Brockwell House, c.1925

211 Henderson Street

Phi Mu comments on proposed
157 E. Rosemary development

Chapel Hill Town Council
November 29, 2023

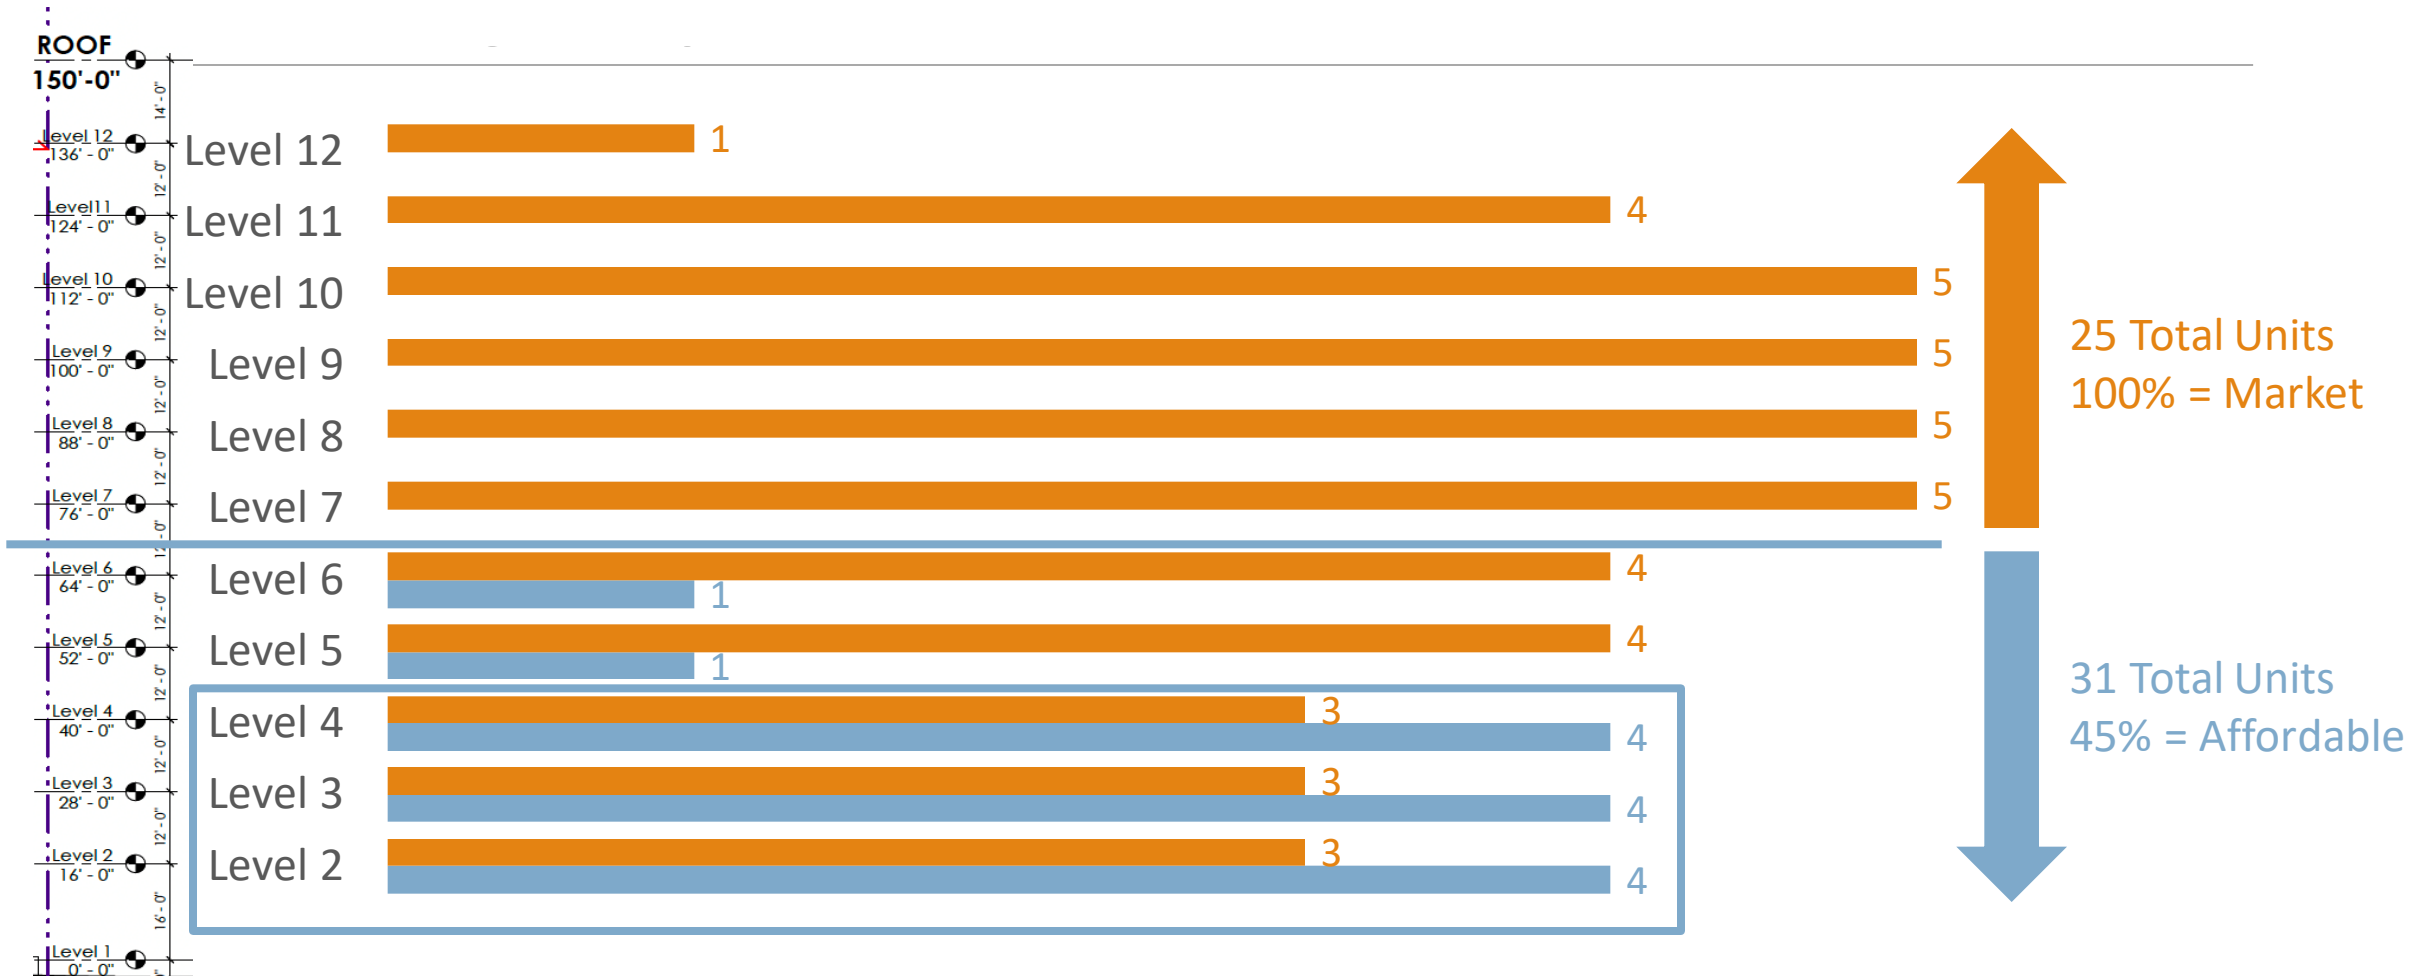
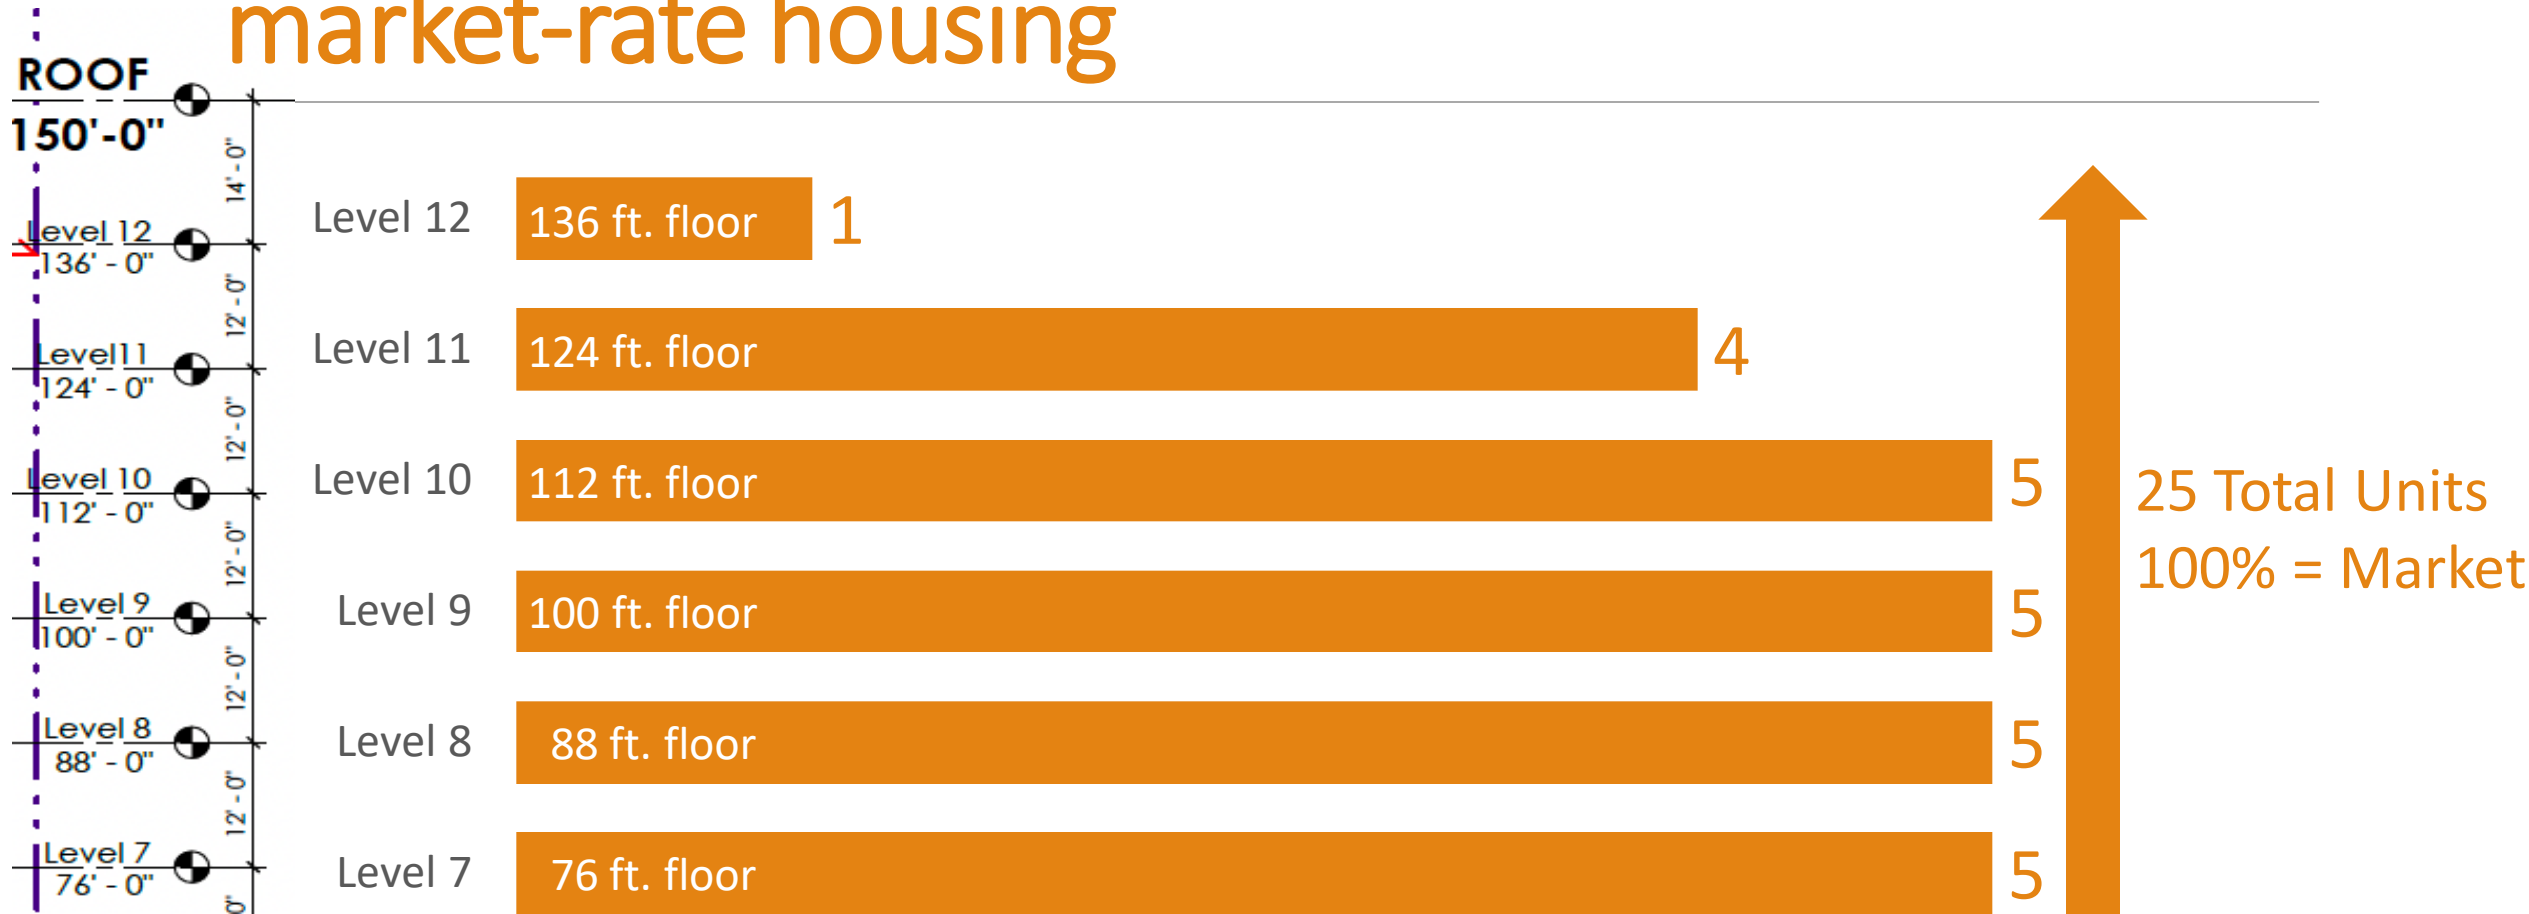
All 14 affordable units are on levels 2-6

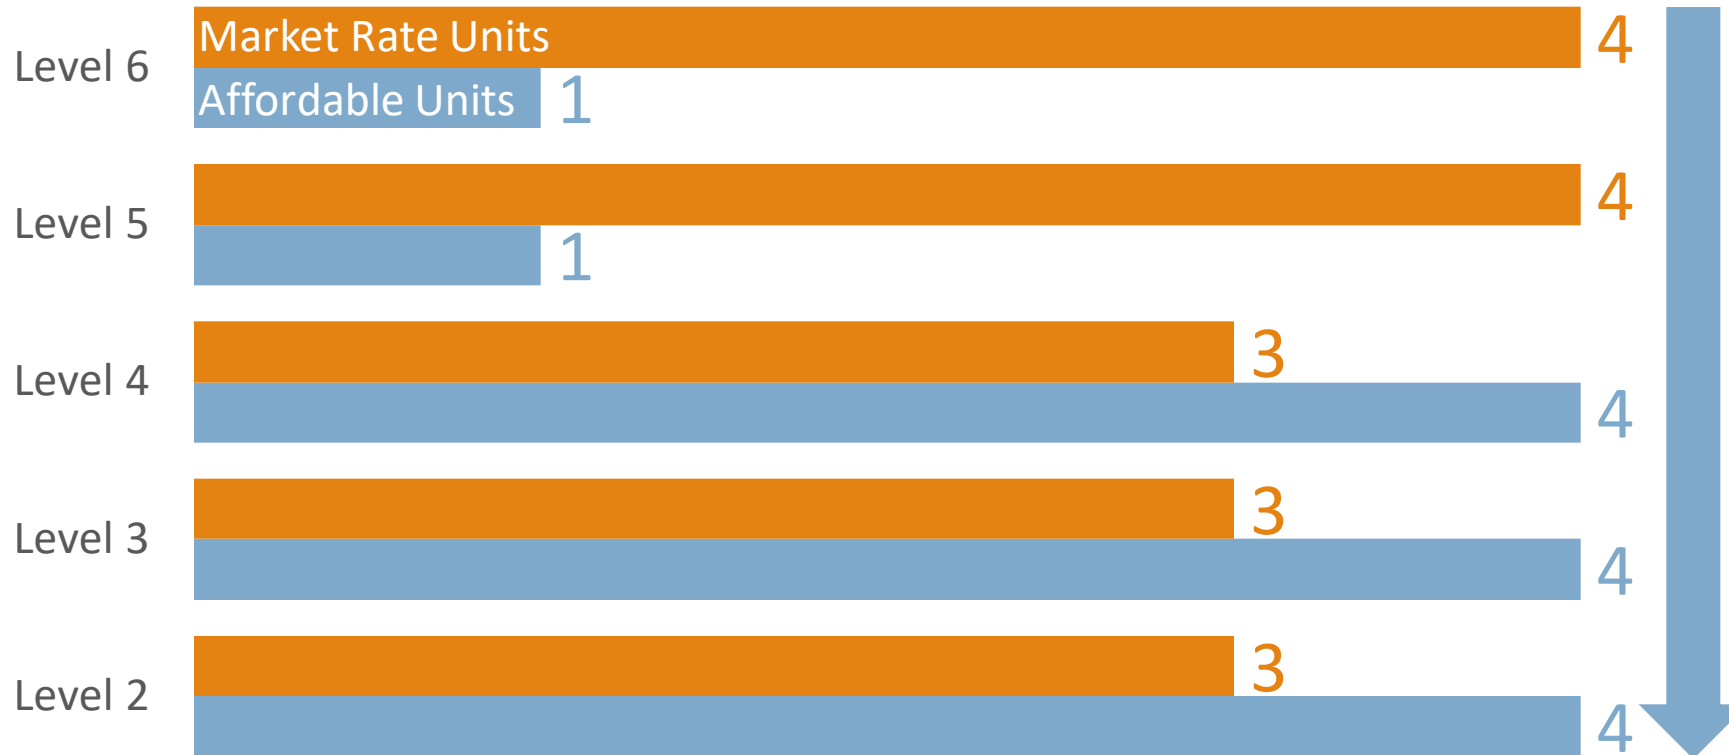
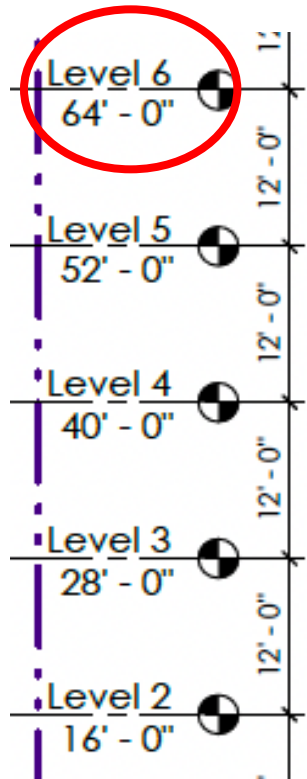
100% of the additional height requested is market-rate housing

The 60' core contemplated in R-CP-CZD is exceeded at Level 6 of this design

31 Total Units
45% = Affordable

SIGHTLINE DIAGRAM

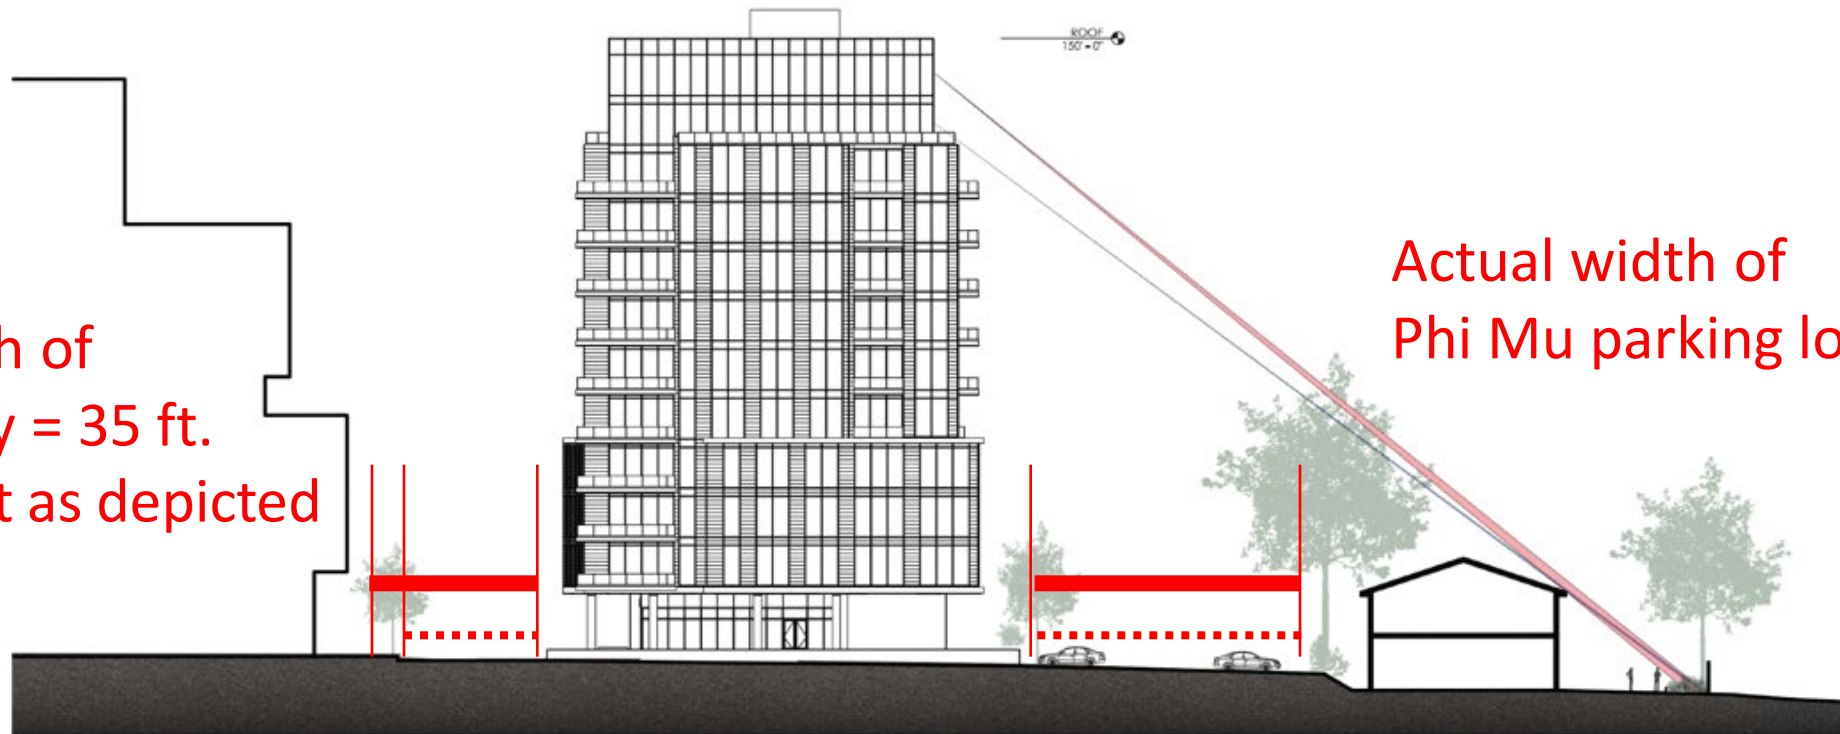
This diagram provided by the developer is not to scale

Actual width of E. Rosemary = 35 ft. vs. 30.5 feet as depicted

Actual width of Phi Mu parking lot = 55 ft.

Without a 3-D Model built to scale that includes differing lot elevations, it's difficult, if not impossible, to visualize how this development would tower over our home and adjacent businesses on E.

SIGHTLINE DIAGRAM

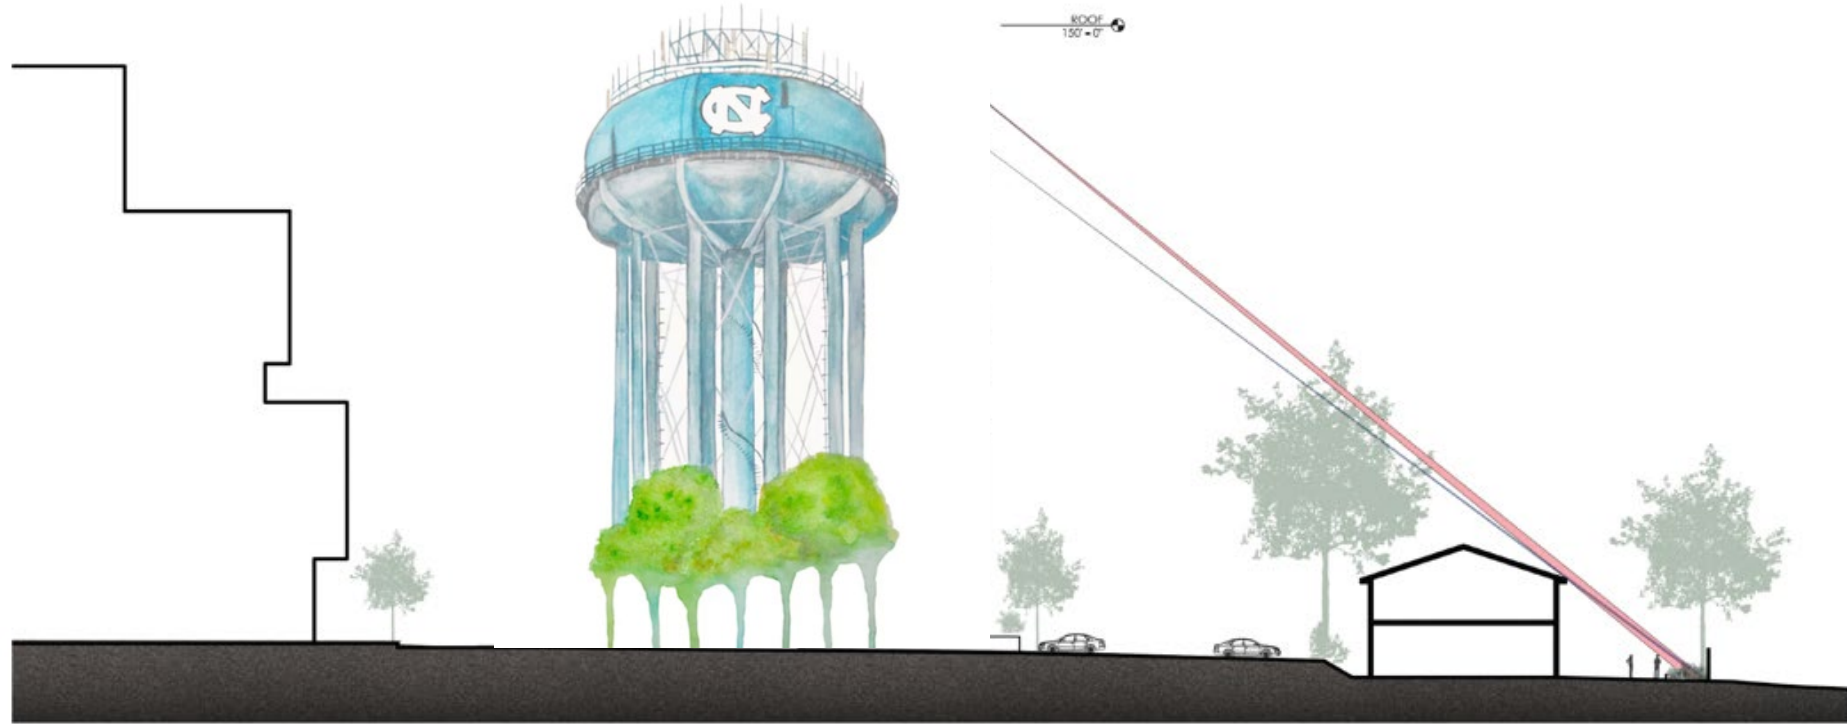
The proposed structure is 7 feet taller than the Manning Drive UNC Water Tower
